Access Compliance Report

Public Rights-of-Way

Intersection ID: 14253	Main Street: LUTHER_ST	Cross Street: S_TORRENCE_ST	Location:	N
ADA ID: 9C0A59E0988A	Ramp Type: PerpDiag	Initial Pass/Fail: Fail	Overall Compliance: No	Severity Score: 25

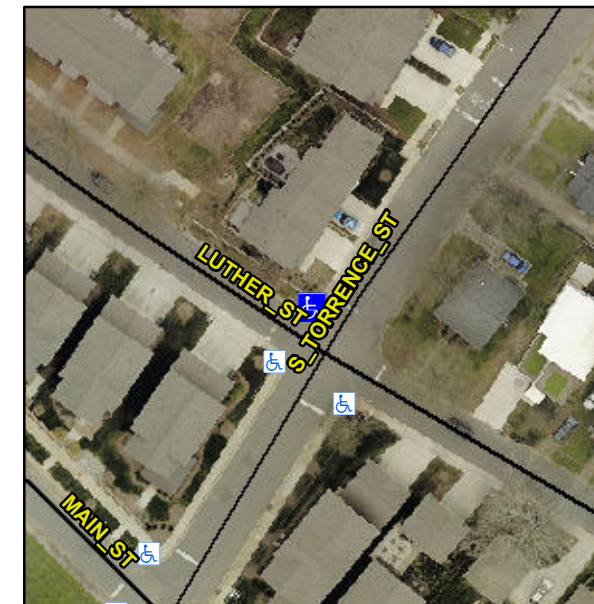
Compliance	Description	Data	Compliance	Description	Data
N/A	Ramp Length (in)	50.0	Yes	Ramp Slope (%)	5.0
Yes	Ramp Width (in)	49.0	No	Ramp XSlope (%)	14.6
N/A	Flare Type LT	N/A	N/A	Flare Type RT	N/A
N/A	Flare Slope LT (%)	N/A	N/A	Flare Slope RT (%)	N/A
N/A	Flare Traversable LT?	N/A	N/A	Flare Traversable RT?	N/A
N/A	Landing Length (in)	N/A	N/A	DWS Provided?	N/A
N/A	Landing Width (in)	N/A	N/A	DWS Contrast?	N/A
N/A	Landing Slope (%)	N/A	N/A	DWS Length (in)	N/A
N/A	Landing X Slope (%)	N/A	N/A	DWS Full Width?	N/A
N/A	Landing Curb? (Y/N)	N/A	N/A	DWS Offset (in)	N/A
N/A	Shared Landing?	N/A			
N/A	Gutter Ponding?	N/A	N/A	Gutter Slope (%)	N/A
N/A	Gutter Lip Ht (in)	N/A	N/A	Gutter X Slope (%)	N/A
N/A	Painted X Walk1?	No	N/A	Painted X Walk2?	No
	X Walk 1 Direction	To SW		X Walk 2 Direction	To SE
N/A	X Walk 1 Width (in)	N/A	N/A	X Walk 2 Width (in)	N/A
	X Walk 1 Slope (%)	5.8		X Walk 2 Slope (%)	4.9
	X Walk 1 X Slope (%)	5.2		X Walk 2 X Slope (%)	7.0

Remove & Replace Curb Ramp With Two New Directional Ramps or Equivalent.

R304.5.3
